Product/Process Change Notice (PCN)

PCN #: ConMPC3_150106_design change
Product Affected: 6620xx21122 & 6620xx235922 &
6623xx235922 & 6620xx231822 & 6623xx231822 &
6620xx21022 & 6620xx236022 & 6621xx236022 &
6620xx230822 & 6621xx230822 & 6620xx231722 &
6621xx231722

PCN Date: January 20th, 2015

Old Design

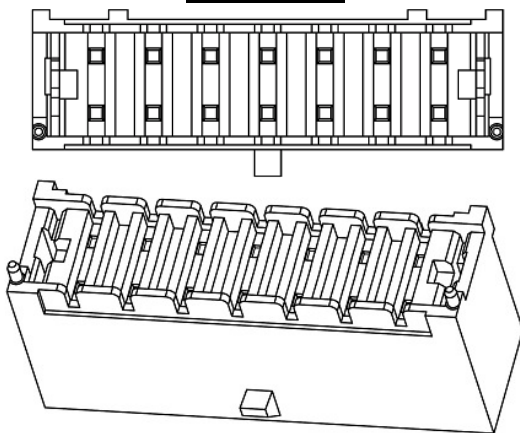
Addition of a rib between pin rows on plastic bodies of MPC3 connectors for better electrical insulation.

The plastic rib increases the creepage distance between the rows of pins and thus insures better electrical insulation. There is no impact on soldering. The air can still flow under the rib on vertical versions of connectors.
